IHOP Facade, JC13-33

Consideration of the request of Trinity Restaurant Group for Preliminary Site Plan and Section 9 Façade Waiver. The subject property is located in Section 14 at 43317 Grand River Ave., south of Grand River Avenue and east of Novi Road in the TC-1, Town Center District. The applicant is proposing to modify the façades of the existing building to accommodate a new IHOP restaurant.

PLAN REVIEW CENTER REPORT May 23, 2013 <u>Planning Review</u> Preliminary/Final Site Plan IHOP Façade JC13-33

Re: FACADE ORDINANCE - Final Site Plan Review IHOP Restaurant, PSP13-0089 Façade Region: 1, Zoning District: TC

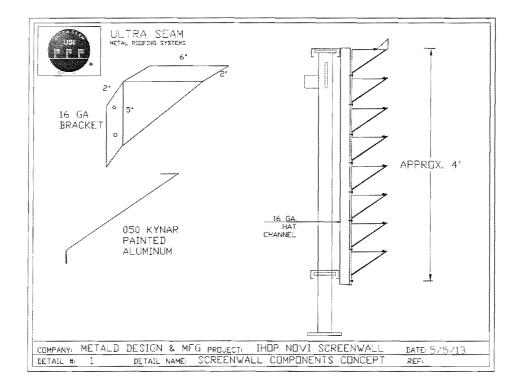
The plan reference to split-faced veneer was changed on the materials board for 2 reasons:

a. We were unable to find a source for the veneer, particular to the size, thickness and color options that could work with the existing conditions.

b. It appeared the split-faced block could be in violation of other material restrictions in the TC1 zone.

Therefore, the submitted sample board showing the Jerusalem Stone in Sahara Beige was an available alternative that addressed a good color option, while maintaining a precise shape (8" \times 16"). Further, the dimensional surface works to compliment and contrast the proposed EIFS.

ELEVATIONS

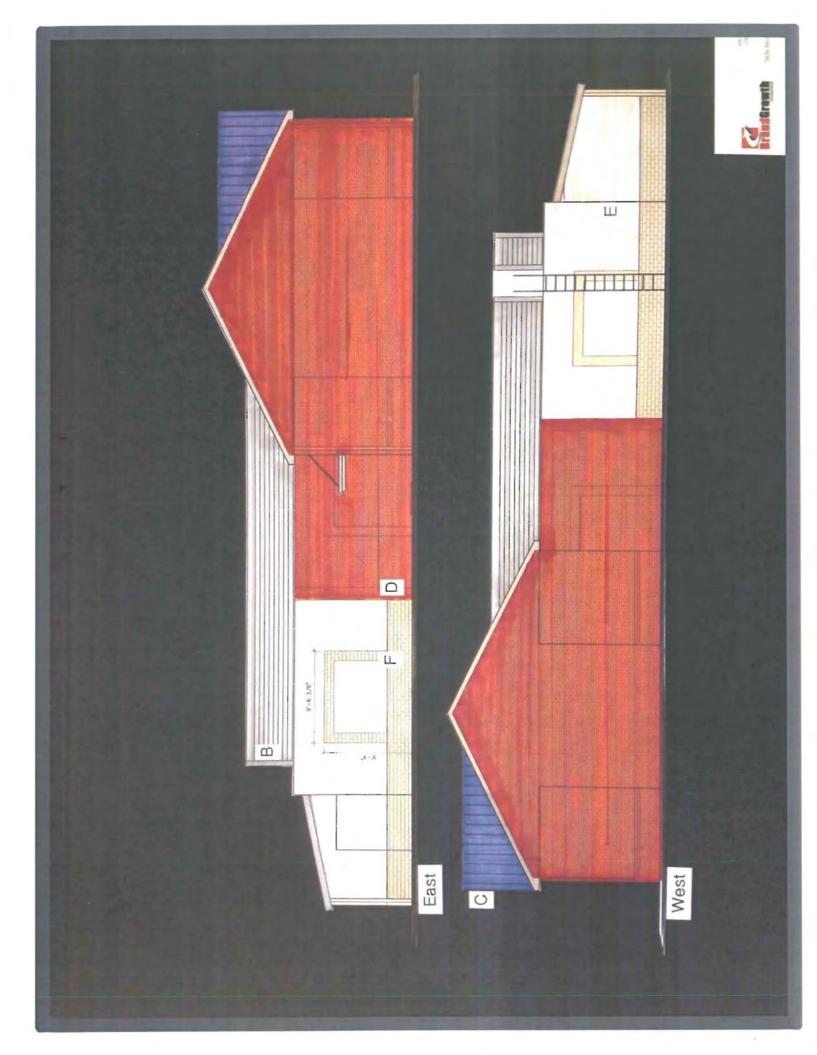
As shown above the percentage of Standing Seam Metal Roof exceeds the Ordnance maximum on the north and south facades and the minimum percentage of Brick is not achieved on the south façade. Several discrepancies were noted between the drawings and the sample board. The sample board was used for this review.

- 1. The sample board indicates Classic Jerusale Sabara Beige Stone Wainscot whereas the drawings indicate Split Faced Veneer Block of an unspecified color.
- 2. The sample board indicates a Louvered Rooftop Equipment Screen constructed of prefinished metal whereas the drawings indicted "new metal equipment screen painted rails, pickets and posts...." The applicant should clarify the roof screen profile and color. Note that ribbed metal is not allowed by the Façade ordinance.

Thank you for the staff report and the findings from Mr. Necci. As requested, this letter is intended to respond to the questions and concerns outlined therein. First, we appreciate the recommendation of support and appreciate your department's accessibility in finding acceptable solutions to the existing building conditions. The items in conflict as outlined in Mr. Necci's letter (plan sheets vs. the material sample board) have been addressed with the architect and the plans are being revised.

FROPOSED TRANSITION AT RRICK AND EIFS/STUCCO

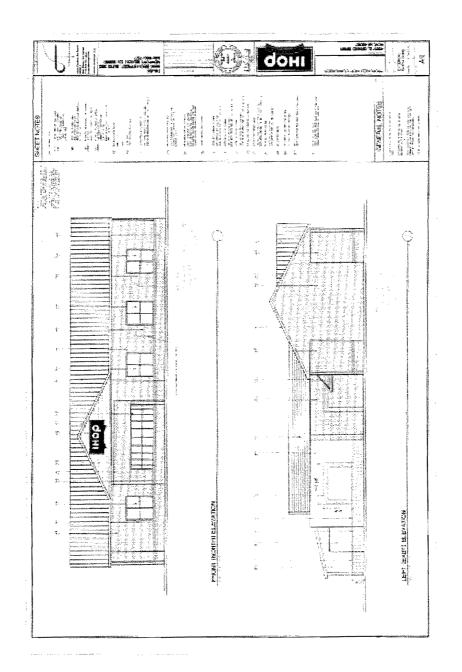
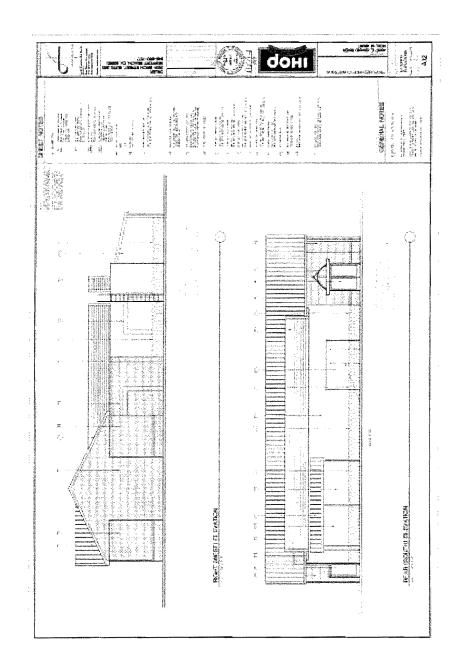
Existing Con	
ranstrion line for new EIFS / Fucco / Stane Wainscot. eit - existing thin brick ancer is tailing.	
Existing Condition	The main third of the second s
